Access Compliance Report

Public Rights-of-Way

Intersection ID: 51439	Main Street: WOODLAND_WATCH_CT	Cross Street: LIPPARDS_HUNT_CT	Location: N
ADA ID: F7AA11AC1DB1	Ramp Type: PerpDiag	Initial Pass/Fail: Fail	Overall Compliance: No
Severity Score: 26.25			
Codes/Mitigation Info/Possible Solution		Field Measurements/Component Compliance

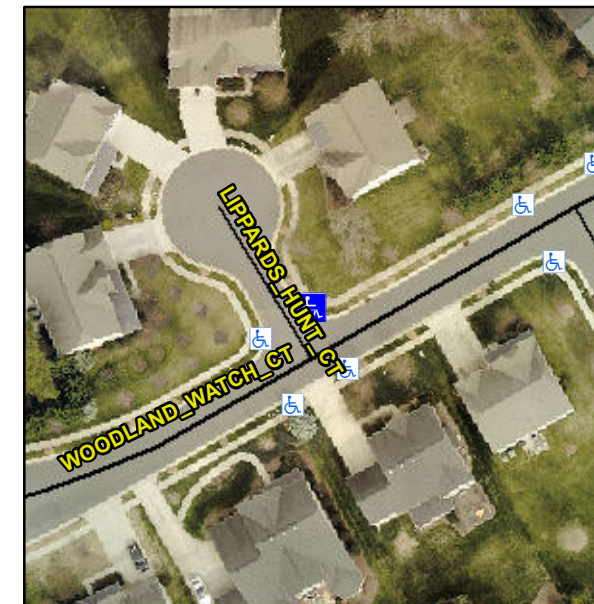
Not Found, R304.2.2, R304.5.3

Compliance	Description	Data	Compliance	Description	Data
N/A	Ramp Length (in)	45.0	No	Ramp Slope (%)	14.4
Yes	Ramp Width (in)	48.0	No	Ramp XSlope (%)	4.9
N/A	Flare Type LT	N/A	N/A	Flare Type RT	N/A
N/A	Flare Slope LT (%)	N/A	N/A	Flare Slope RT (%)	N/A
N/A	Flare Traversable LT?	N/A	N/A	Flare Traversable RT?	N/A
N/A	Landing Length (in)	N/A	N/A	DWS Provided?	N/A
N/A	Landing Width (in)	N/A	N/A	DWS Contrast?	N/A
N/A	Landing Slope (%)	N/A	N/A	DWS Length (in)	N/A
N/A	Landing X Slope (%)	N/A	N/A	DWS Full Width?	N/A
N/A	Landing Curb? (Y/N)	N/A	N/A	DWS Offset (in)	N/A
N/A	Shared Landing?	N/A			
N/A	Gutter Ponding?	N/A	N/A	Gutter Slope (%)	N/A
N/A	Gutter Lip Ht (in)	N/A	N/A	Gutter X Slope (%)	N/A
N/A	Painted X Walk1?	No	N/A	Painted X Walk2?	No
	X Walk 1 Direction	To SW		X Walk 2 Direction	To SE
N/A	X Walk 1 Width (in)	N/A	N/A	X Walk 2 Width (in)	N/A
	X Walk 1 Slope (%)	4.6		X Walk 2 Slope (%)	0.1
	X Walk 1 X Slope (%)	2.0		X Walk 2 X Slope (%)	5.9

N/A	Ramp inside XWalk1?	N/A	N/A	Ramp inside XWalk2?	N/A
	Road Slope (%)	5.7	N/A	Clear Space?	N/A
	Road X Slope (%)	2.8	N/A	Clear Space to XWalk (in)	N/A
N/A	Any Obstructions?	N/A	N/A	Storm Grate/Utility Hazard?	N/A
	Obstruction Type			Storm Grate/Utility Type	
		N/A			N/A
			Yes	Surface Condition? (G/P)	Good

Remove & Replace Curb Ramp With Two New Directional Ramps or Equivalent.
